Type <b>Coffee Vending Machine</b>	Model <b>9200 CV – 9100 IN</b>	N° T.I. <b>09 - 2018</b>
Serial Number <b>See page 2/2</b>	Subject <b>CHANGE of HEATING ELEMENT ASSEMBLY SEQUENCE</b>	ISSUED FOR (X)
		Action Information <b>X</b>

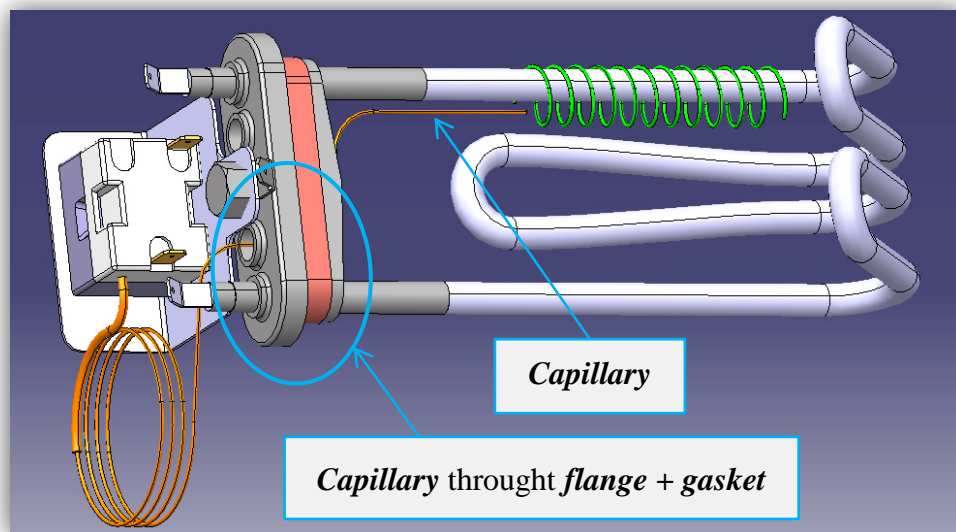
The dry boil protection is failing after a short time in operation.

This is caused by corrosion / rust following an overstressing of the welding.

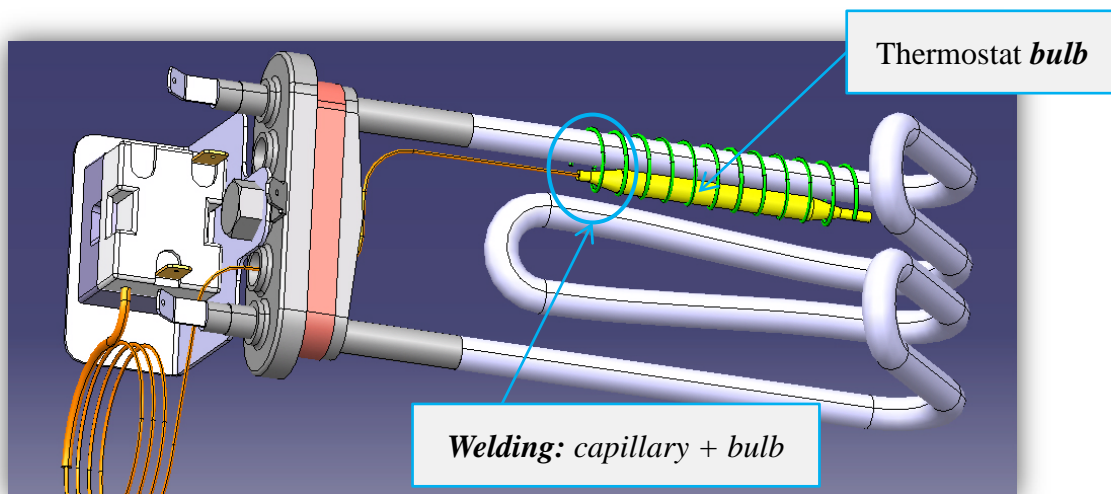
The *heating elements assembly sequence* has been modified.

1. the capillary is now assembled through the *flange + gasket*

2. **weld** the thermostat *bulb* to the **capillary**
